Proposed Updated Final Safety Analysis Report Tables and Figures
(Mark-Ups; for Information Only)
(164 pages follow)

FINAL PLANT LAYOUT, PLAN C ABOVE
ELEVS. 620'-6", 623'-6" AND
624'-6", PLANT COMPLEX
FIGURE 1.2-5
(DWG. E-013-0005-00000)

Figure 2.4-37

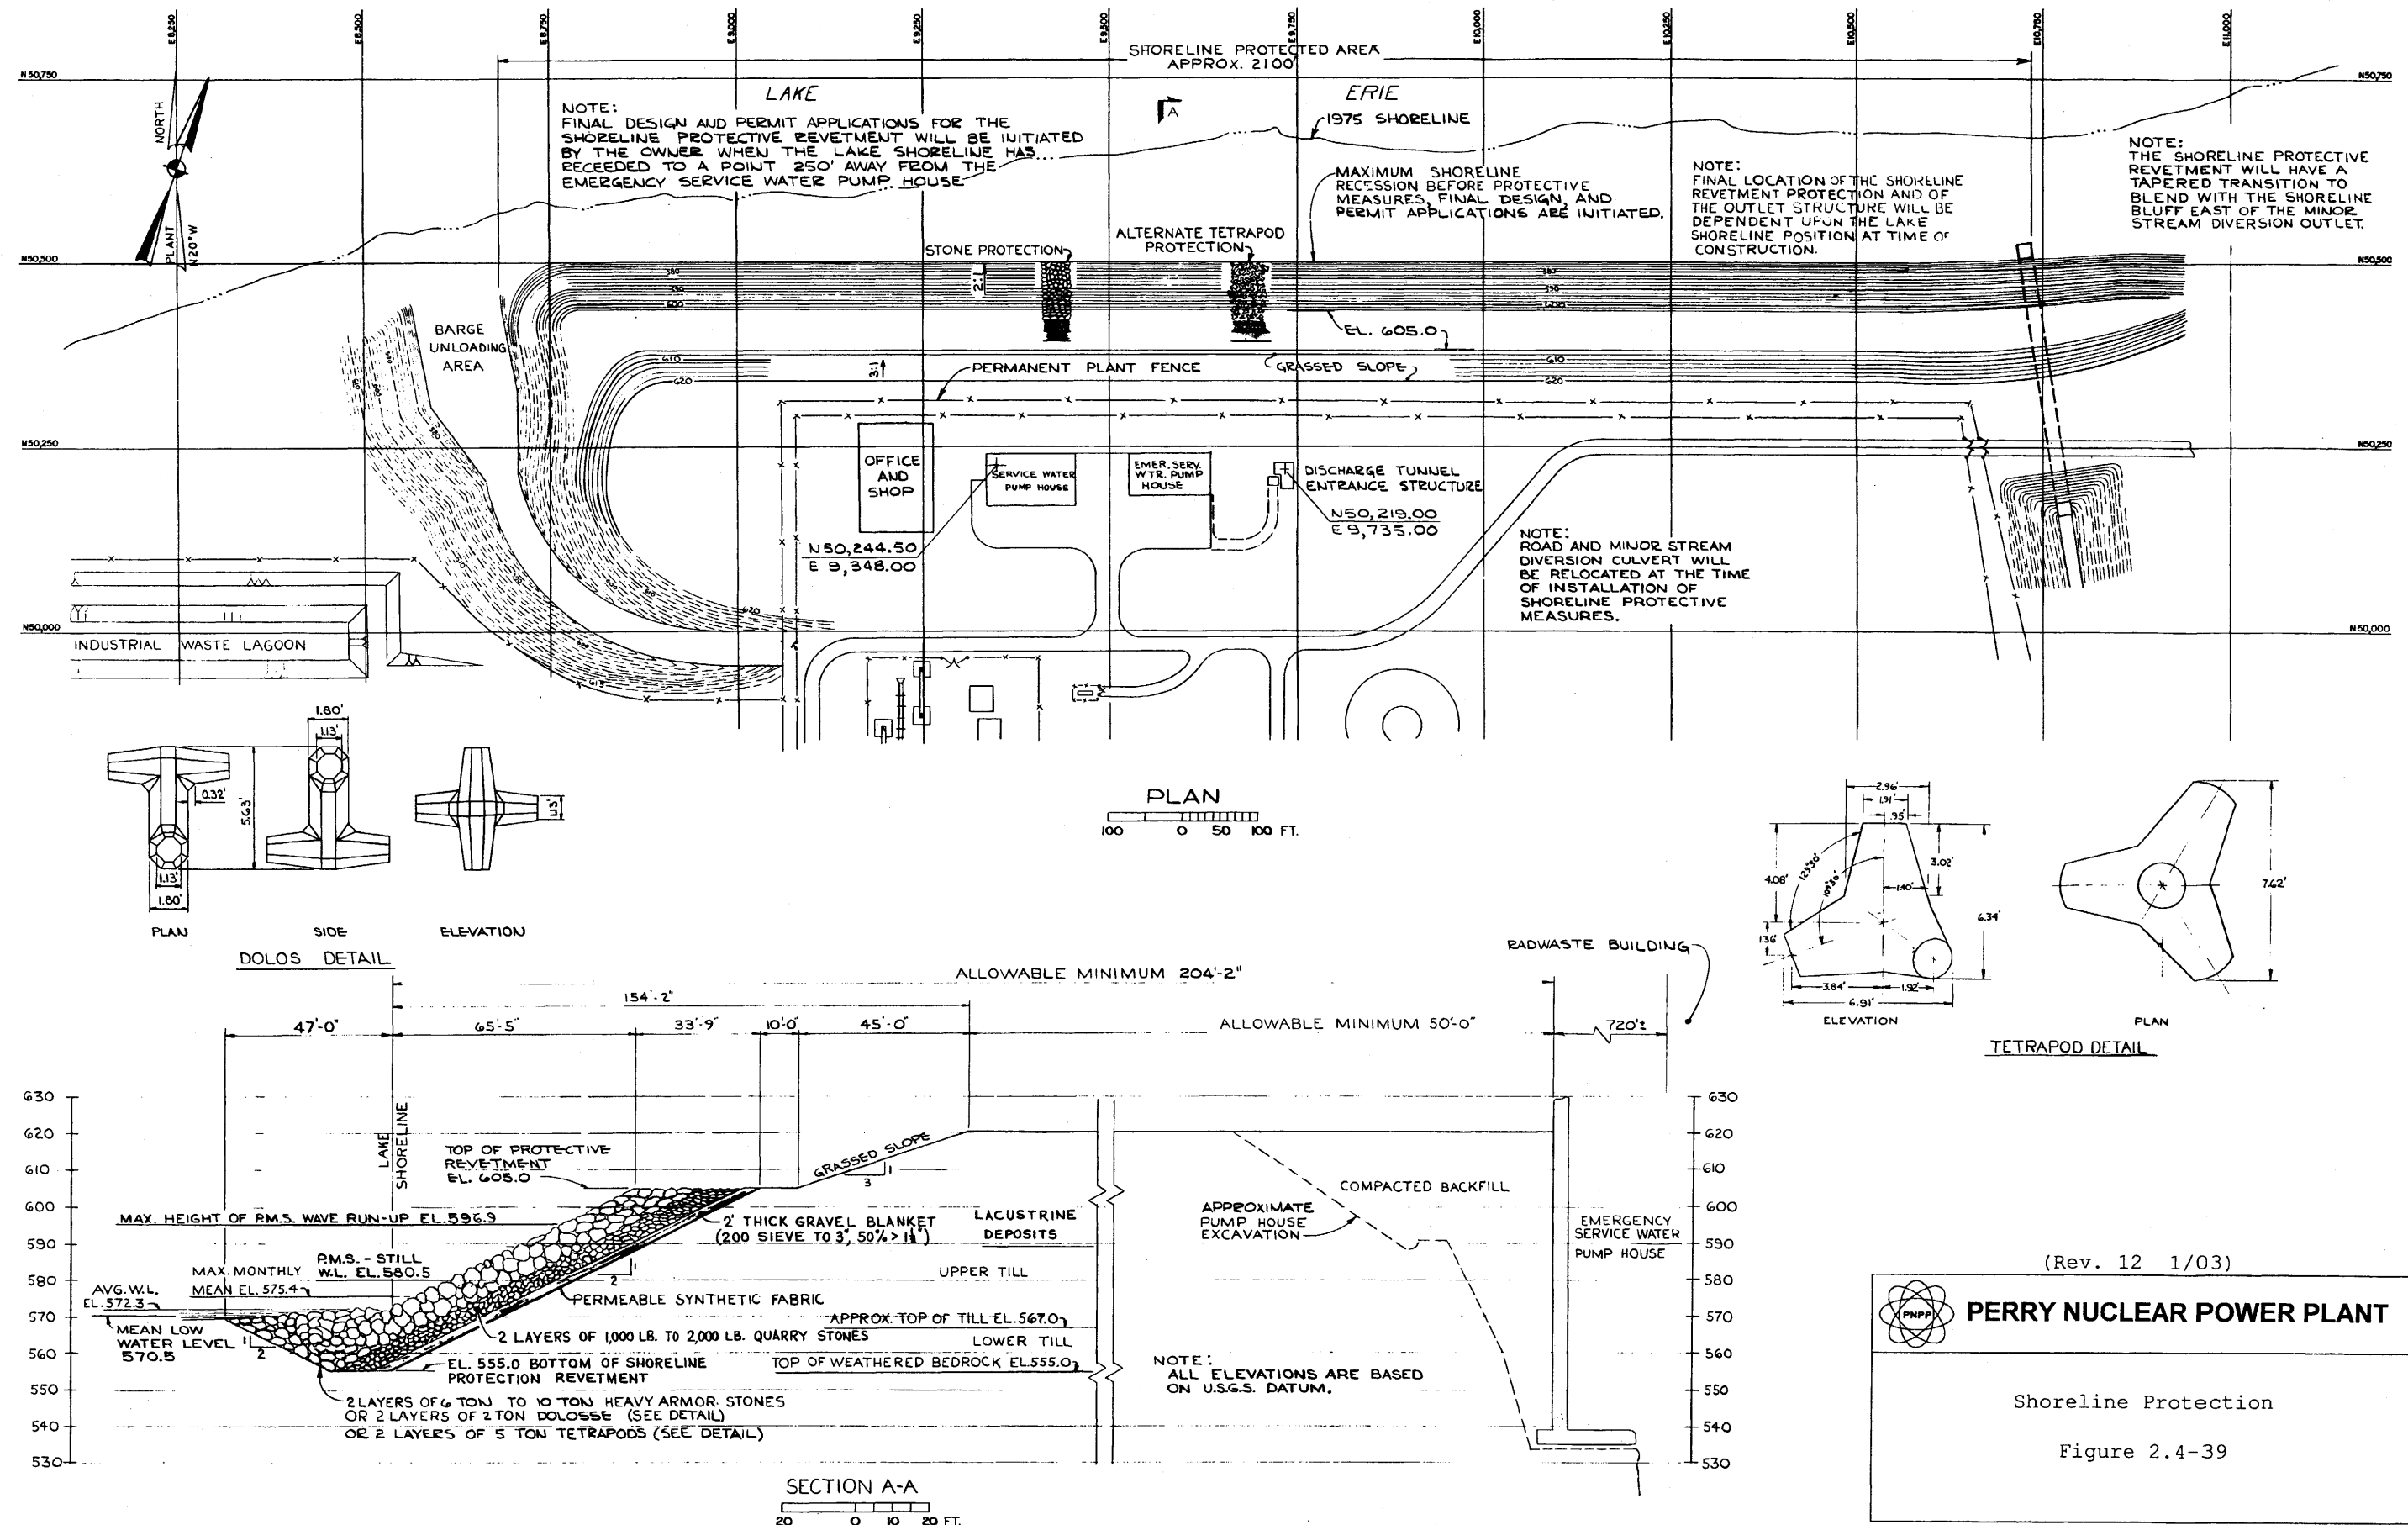
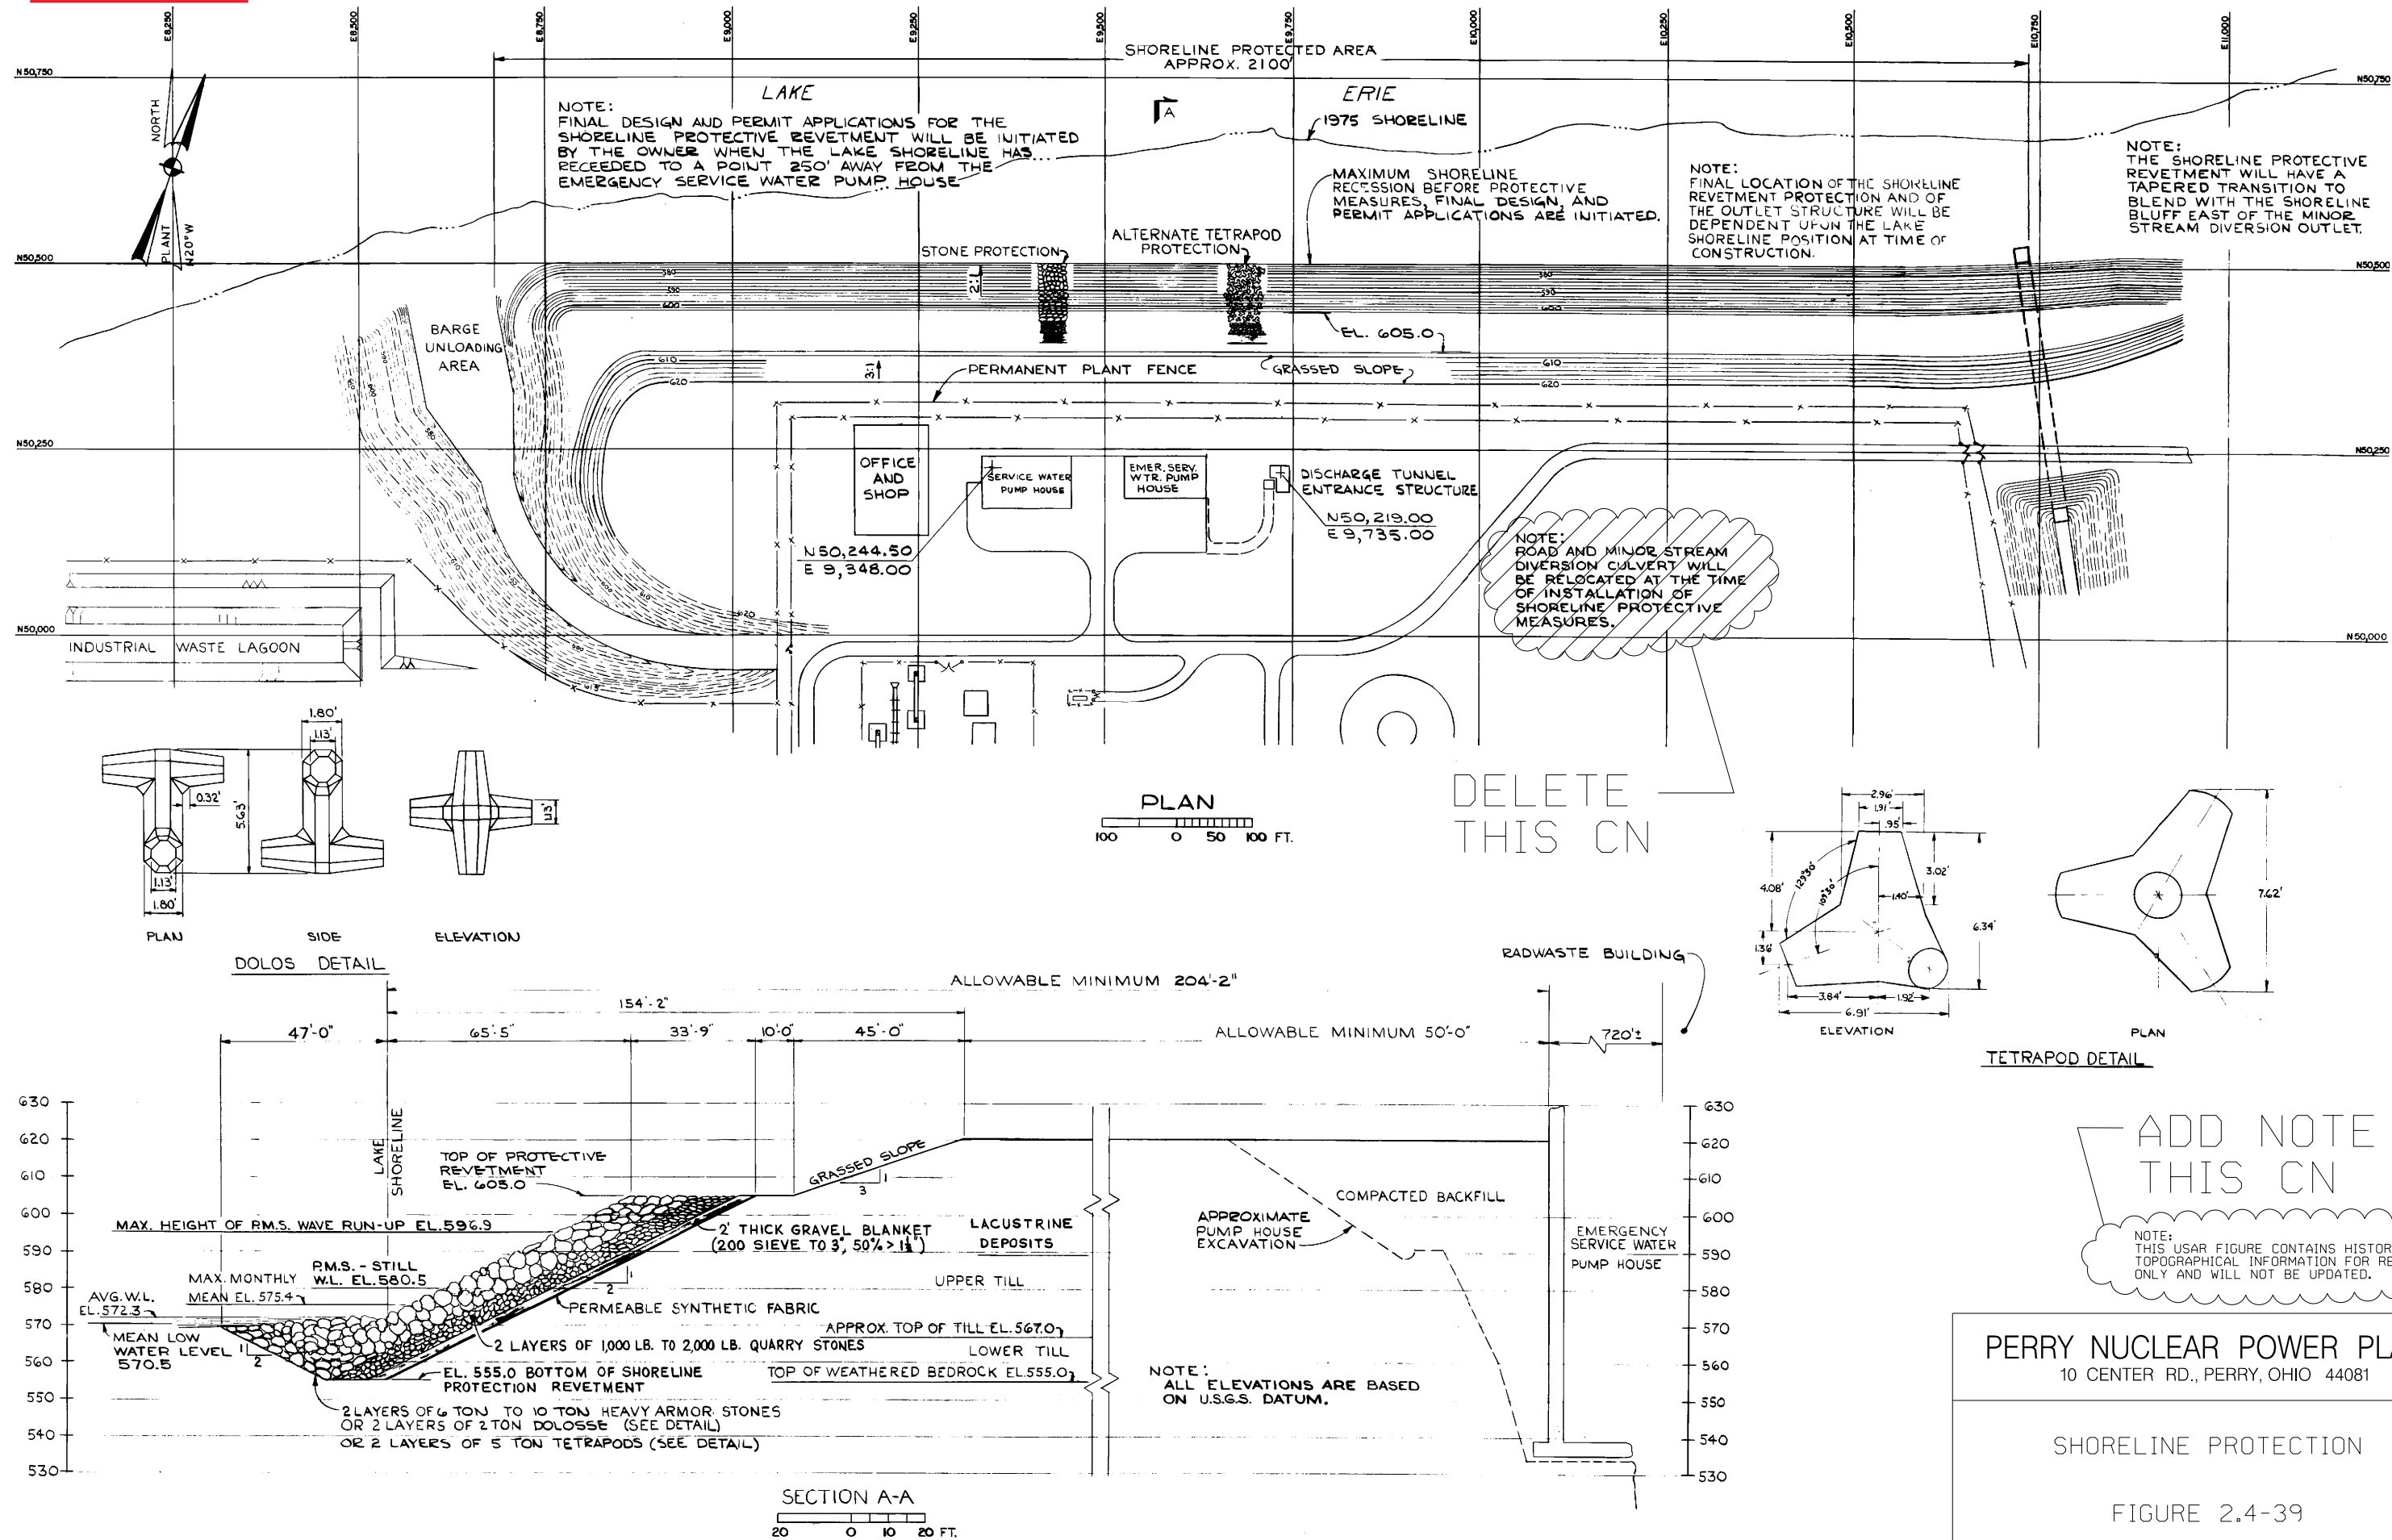
ADD NOTE
THIS CN

NOTE:
THIS USAR FIGURE CONTAINS
HISTORICAL TOPOGRAPHICAL
INFORMATION FOR REFERENCE
ONLY AND WILL NOT BE UPDATED.

Figure 2.4-39A

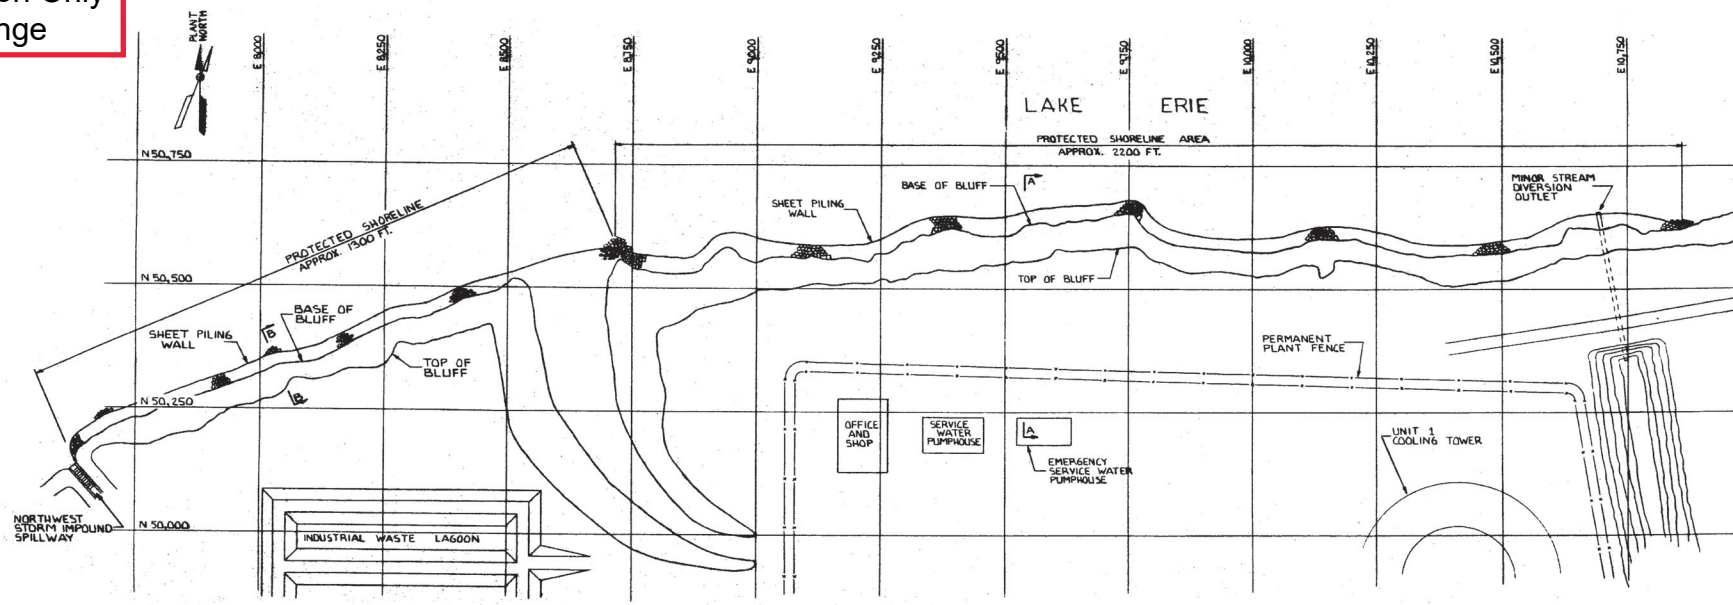
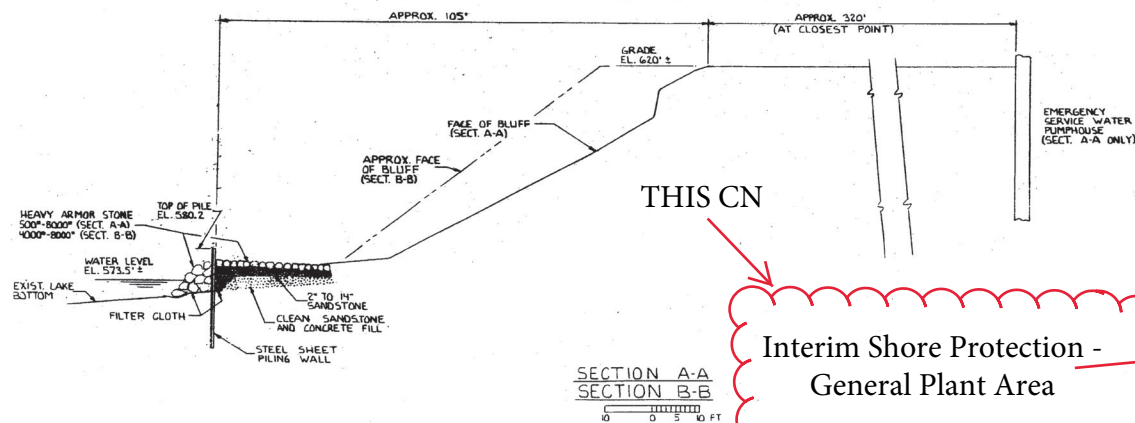
ADD NOTE
THIS CN

- NOTES:
1. THIS USAR FIGURE CONTAINS HISTORICAL TOPOGRAPHICAL INFORMATION FOR REFERENCE ONLY AND WILL NOT BE UPDATED.
 2. FOR DIVERSION STREAM INTERIM SHORE PROTECTION SEE FIGURE 2.4-39B

PERRY NUCLEAR POWER PLANT
Well Location Map	
Figure 2.4-66

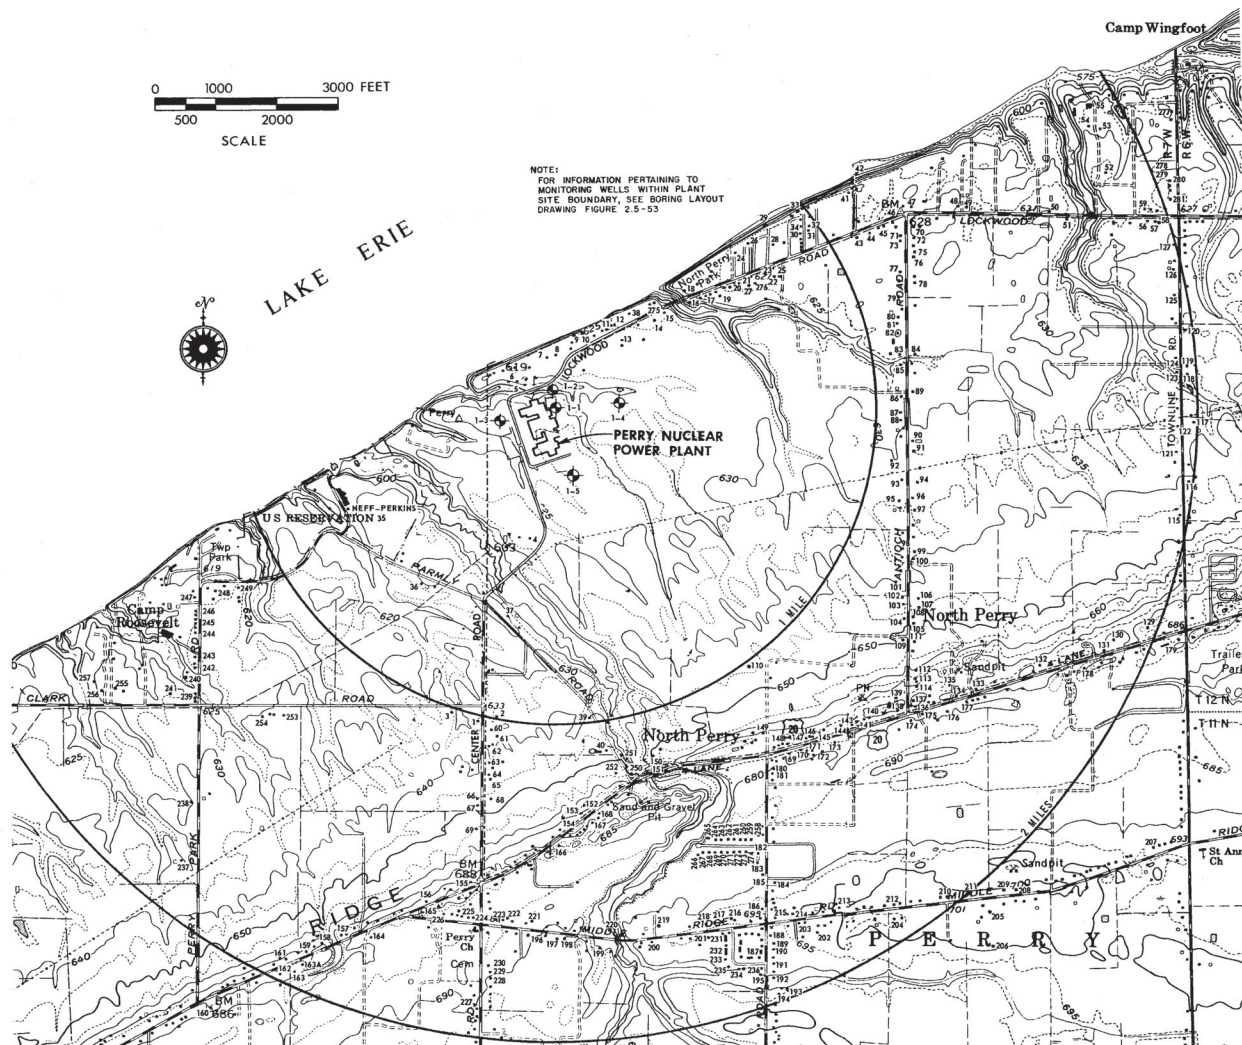
ADD NOTE
THIS CN

NOTE:
THIS USAR FIGURE CONTAINS
HISTORICAL TOPOGRAPHICAL
INFORMATION FOR REFERENCE ONLY
AND WILL NOT BE UPDATED.
